**Cumberland County
Subdivision and Land Development
Review Report**

Municipality:	Date Received:	Date Reviewed:	Reviewed By:	Plan Number:
Middlesex Township	12/16/2025	1/12/2026	SH, EG, KS	P25-1176
Plan Title:				
Pennsylvania Digital 1 (PAX-1) Phase 2				
Plan Status:		Plan Type:		
Preliminary		Land Development Plan		
Comments and Recommendations:

EXISTING
CONDITIONS &
DEMO PLAN

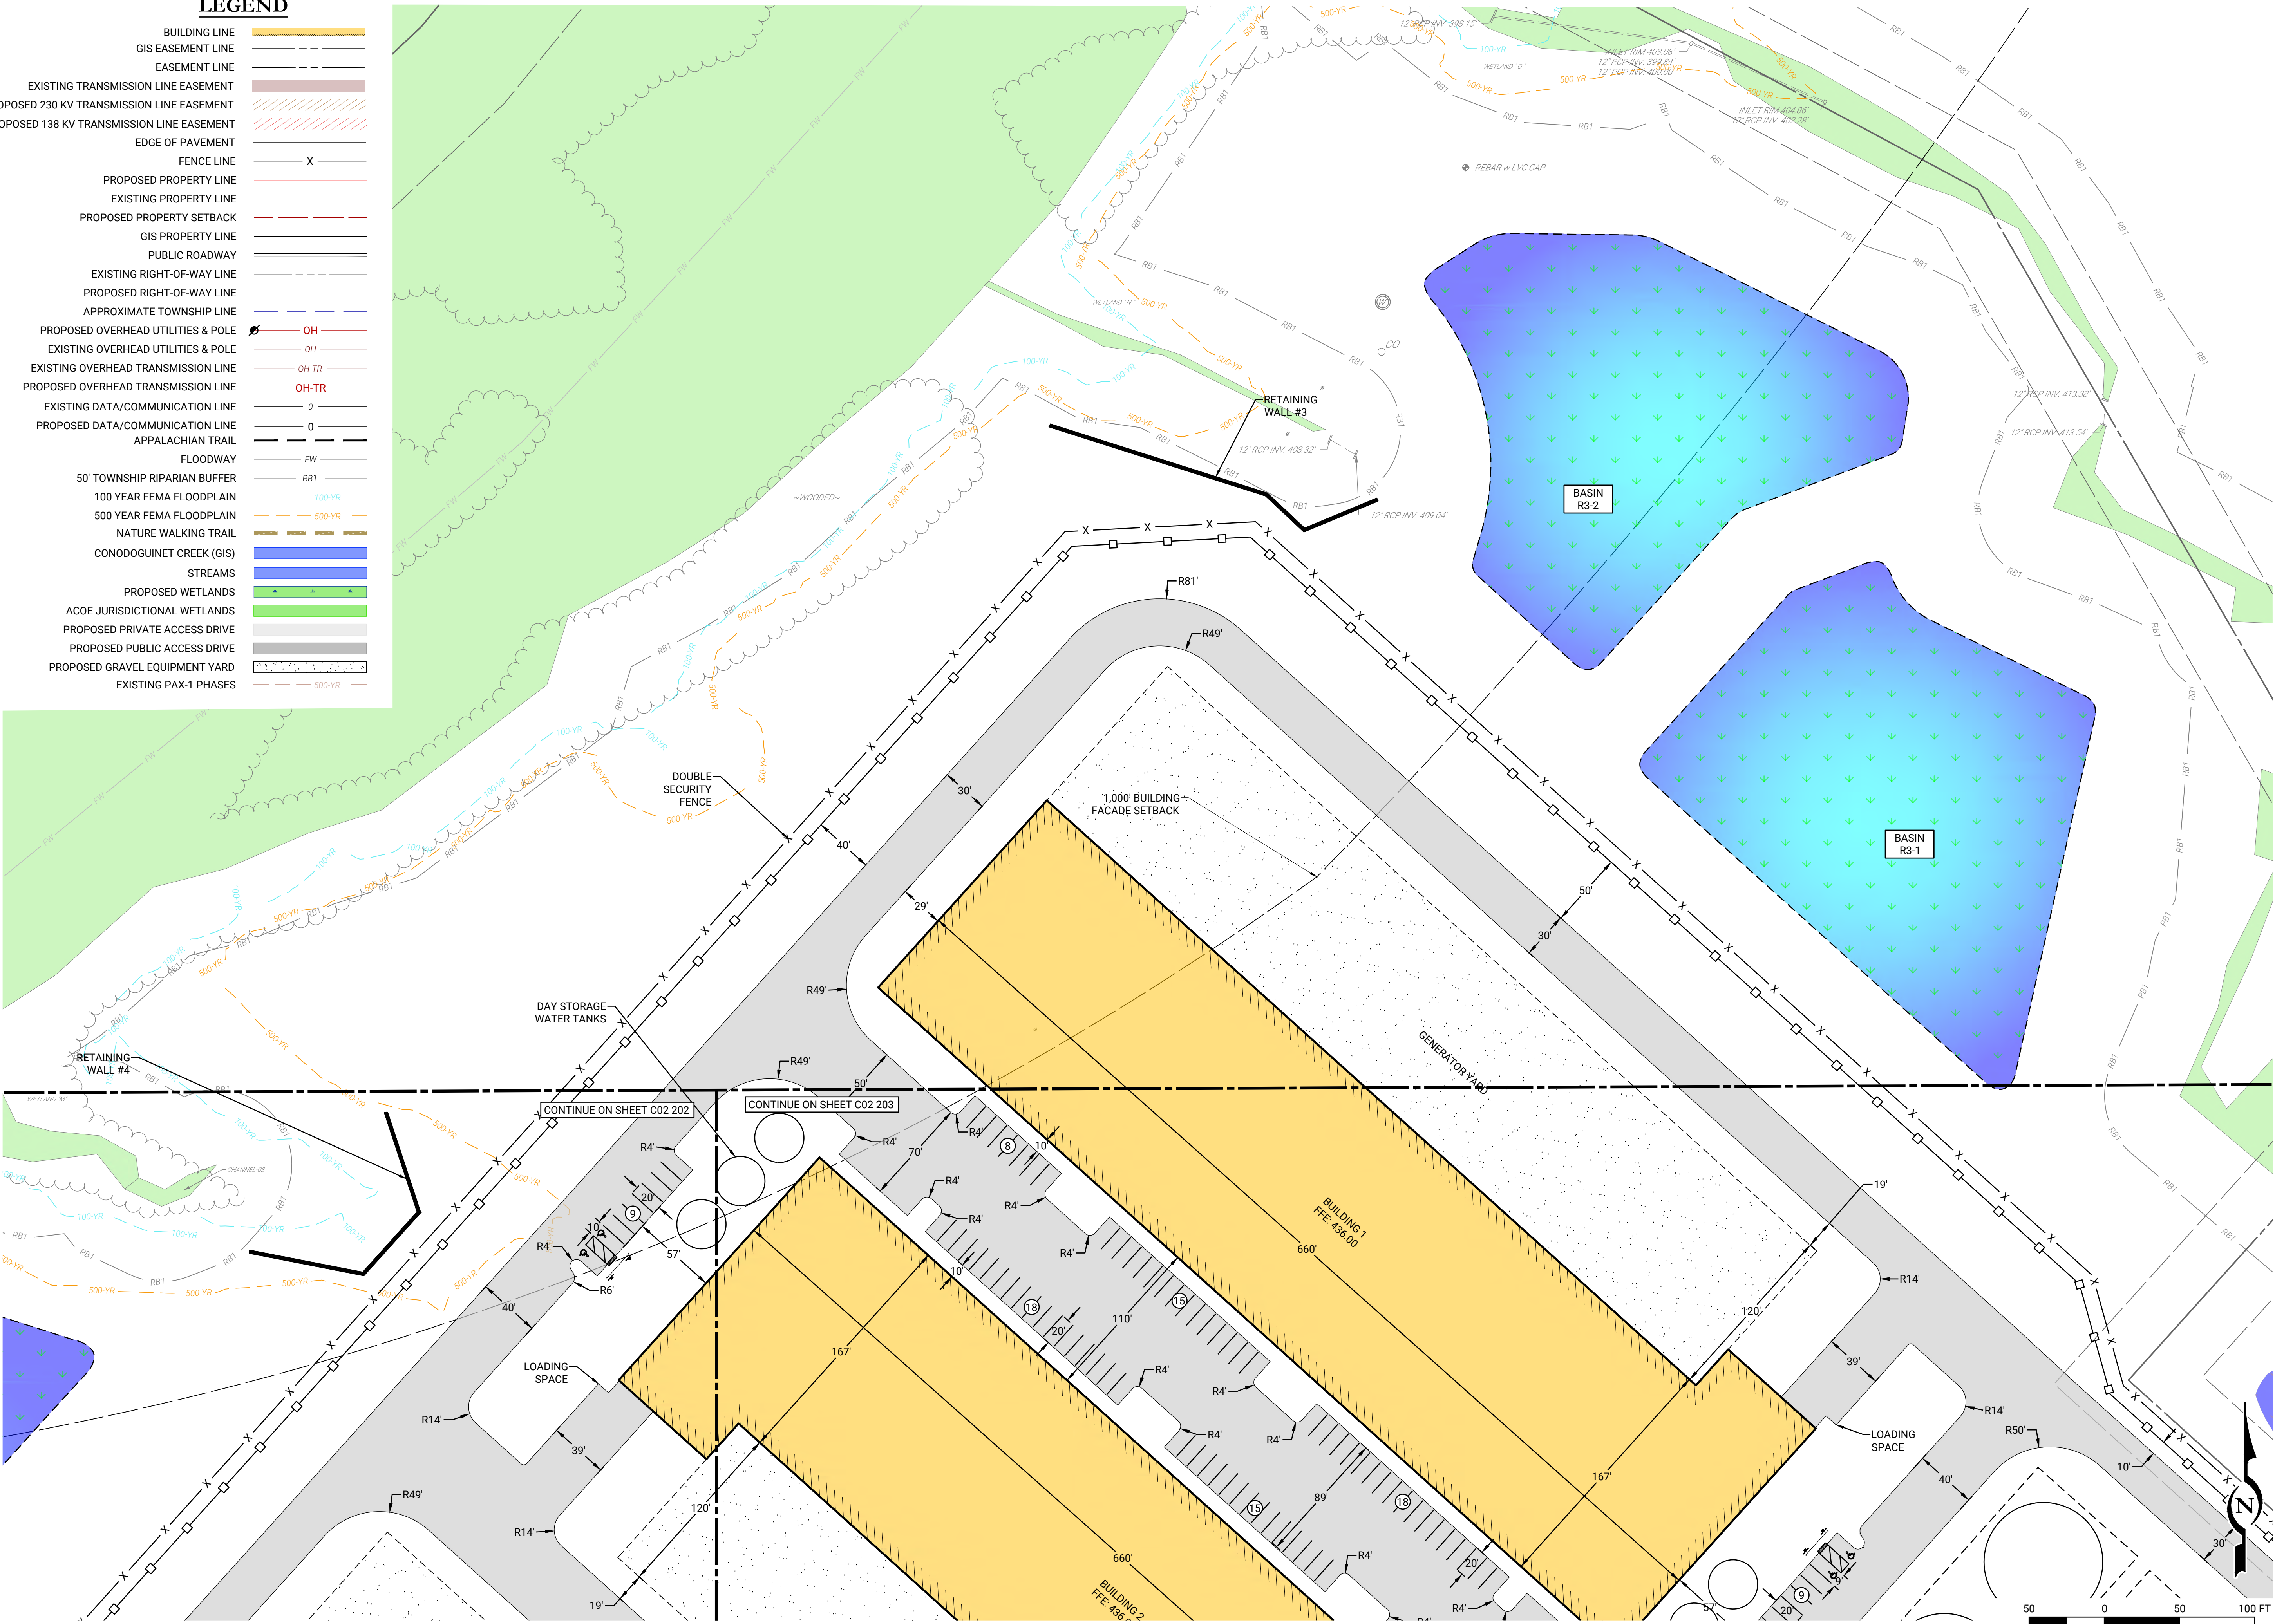
- i. The applicant should consider the feasibility of installing tanks to hold the excess stormwater to be used for cooling the data center.
 - ii. The existing conditions and demo plan indicates that many areas along the floodplain include steep banks and sensitive features that may be susceptible to erosion from increased stormwater flow. The township should require methods to limit erosion prior to approval of the waiver

38. The existing driveway on the existing conditions plan should be labeled.

SHEET NO. C02 601

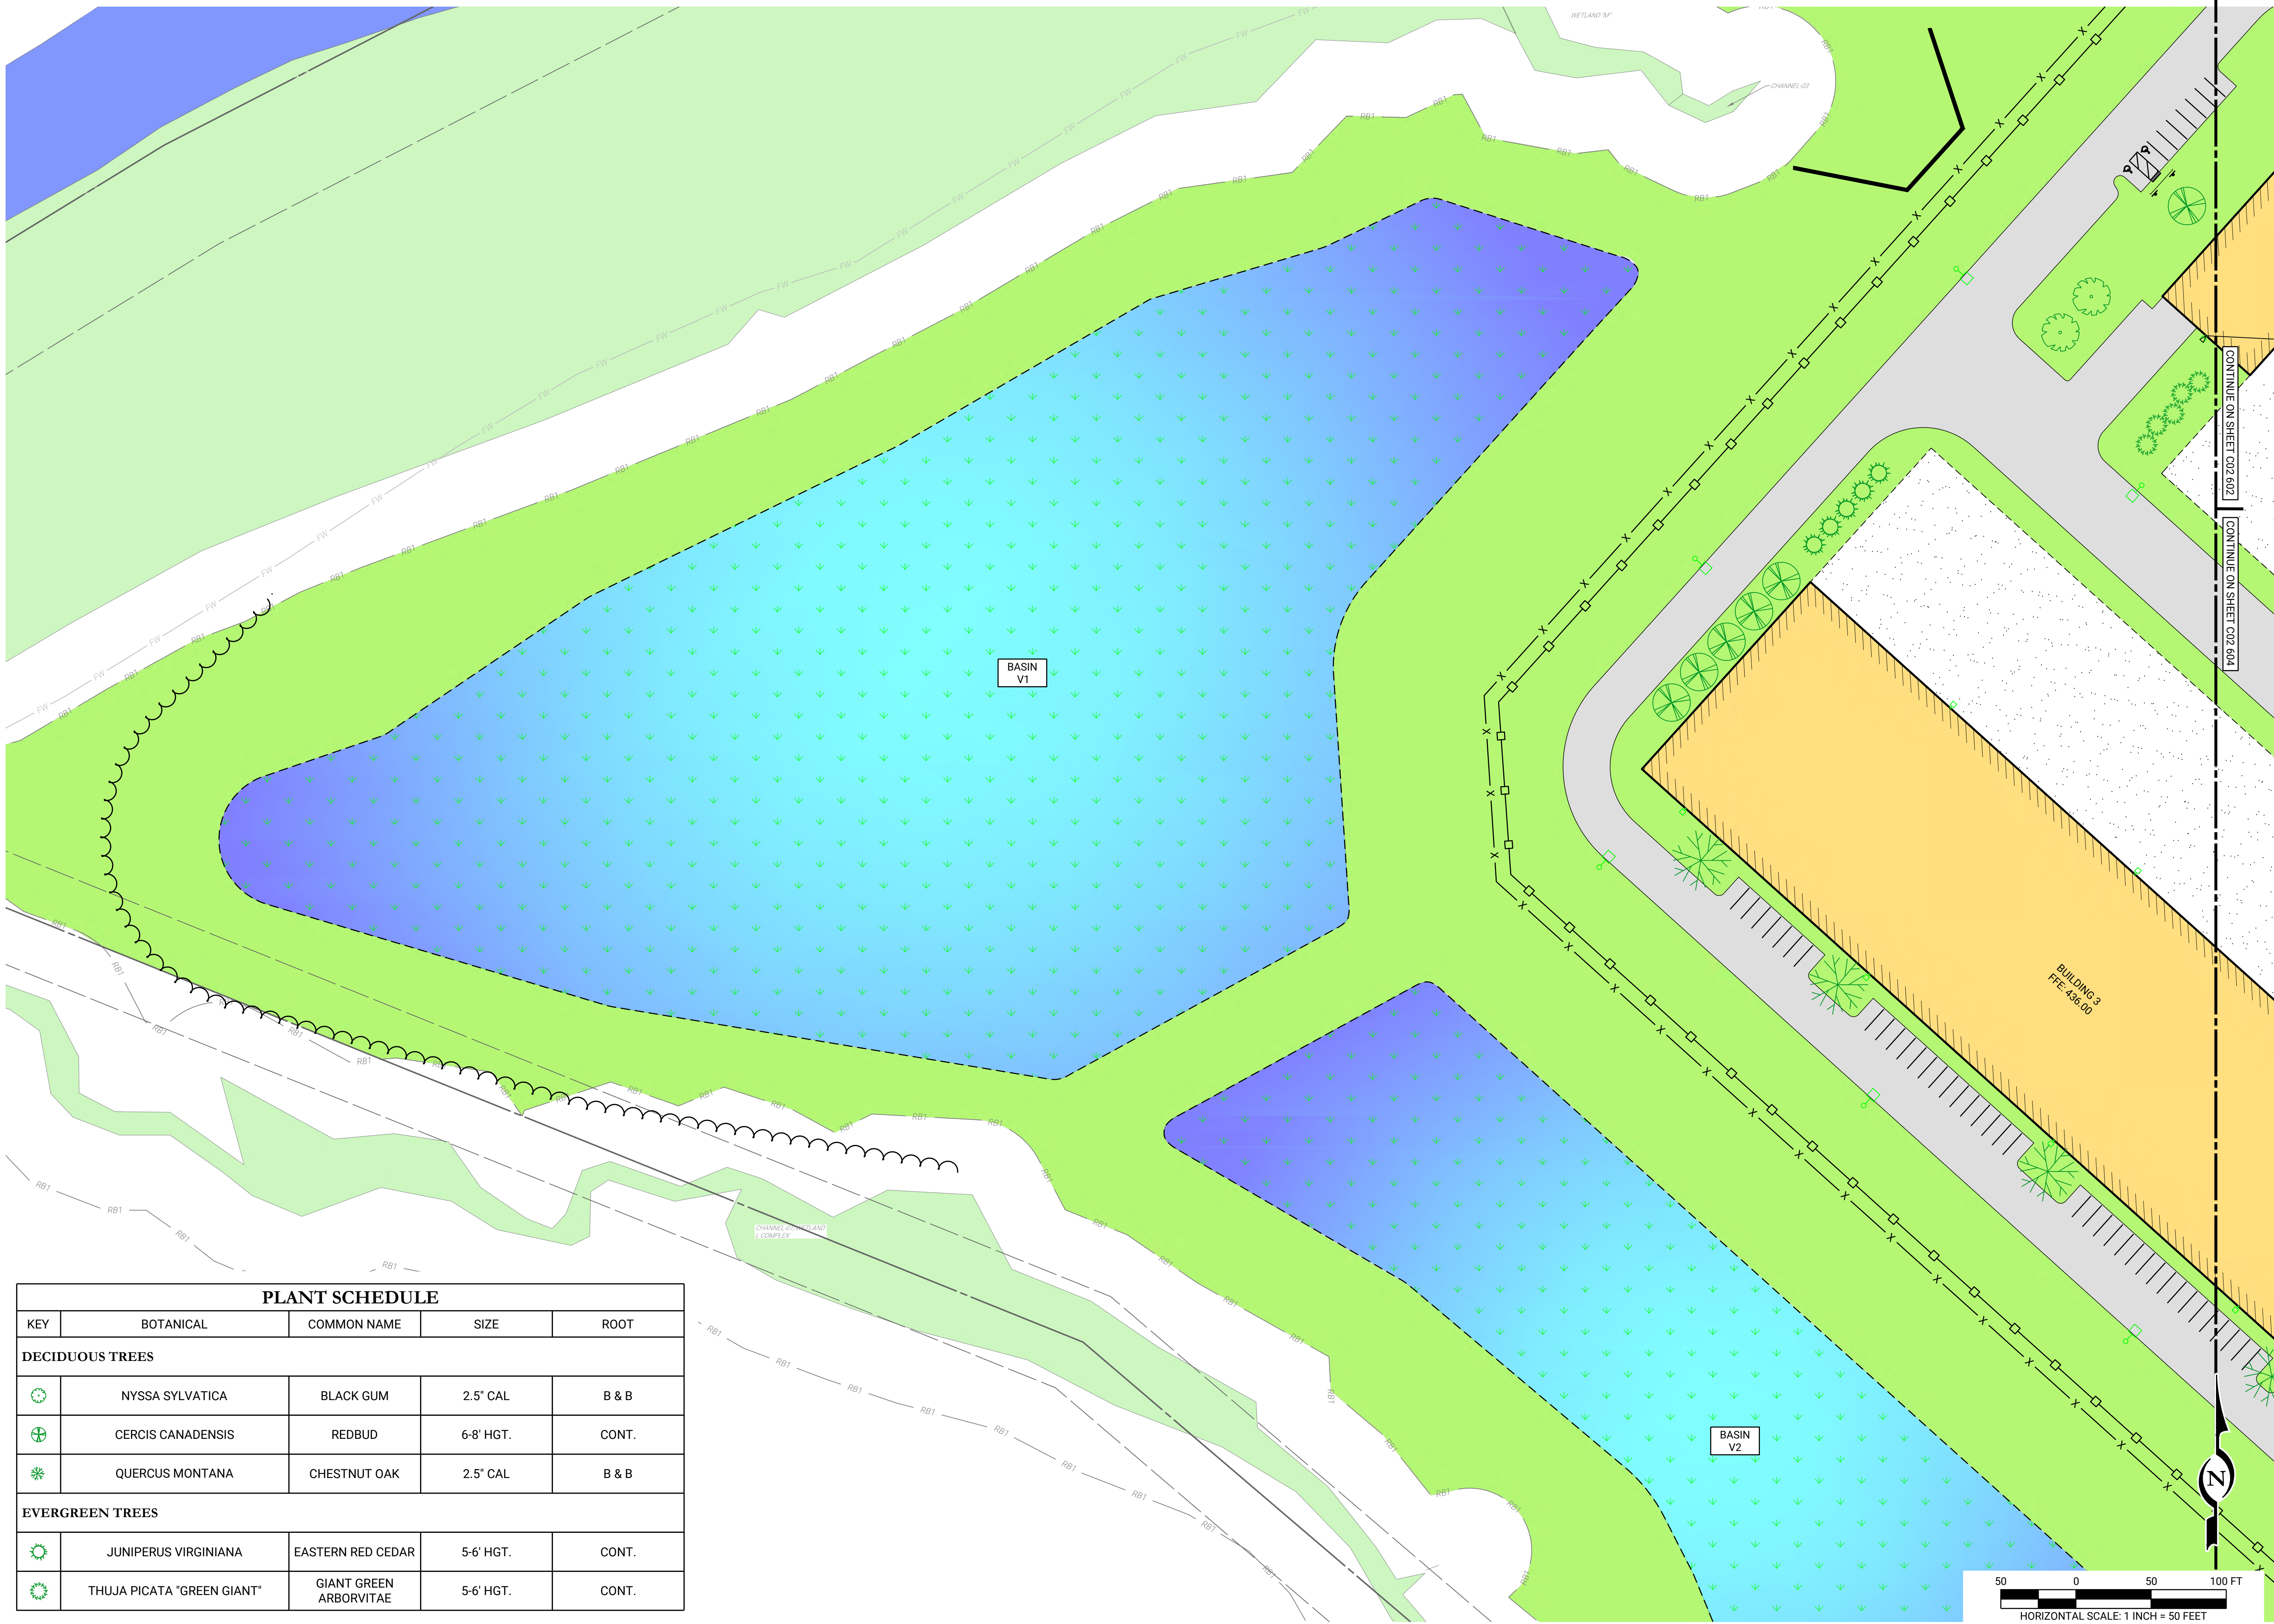
39. Sheet C02 601 includes an overall plant schedule and includes a reforestation area on the lower left corner of the sheet. The reforestation area planting breakdown note should include a sheet number.

40. Sheet C02 607 shows reforestation area 1 and reforestation area 2. Areas 1 and 2 should also be identified on the overall landscaping plan (sheet C02 601).
